Livable Housing Report

1112-1116 Barrenjoey Road

Project: 1112-1116 Barrenjoey Rd, Palm Beach
Document Type: Livable Housing Design Guidelines Assessment Report
Our Reference: P221_249-3 (LHA DA) DY

Figure 1 – Level 1 – Unit 102

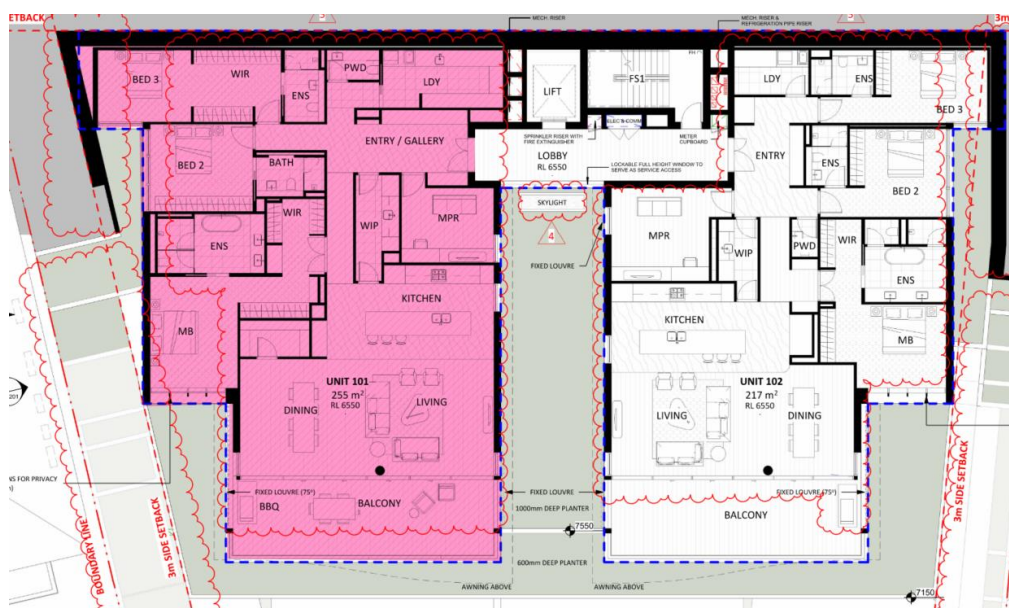
A total of five (5) residential units are proposed within the subject development. Units 102 are designated as Liveable. The Pittwater 21 Development Control Plan – Section C1.9 requires a min. 20% of the dwellings in a Shop Top housing and Mixed Use developments to be in accordance with Silver Level of the Liveable Housing Guideline.

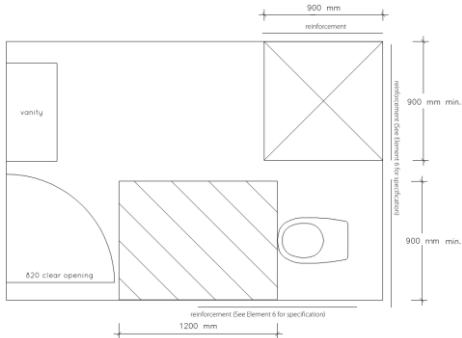
ITEM	REQUIREMENT	ASSESSMENT
Internal Doorways	Doorways to entry level living, dining, bedroom, bathroom, kitchen, laundry and sanitary compartments are required to have a minimum clear opening width of 820mm.	Doors are shown to comply.
Corridor Width	Internal corridors and passageways to have a minimum clear width of 1000mm	Corridor widths are shown to comply.
Specification	Silver level internal doors and corridors specification to be satisfied.	Ensure the Internal Doors & Corridors Specification as listed within Appendix 2 is noted on design and construction drawings, compliant with Design Element 3 of the Livable Housing Guidelines.
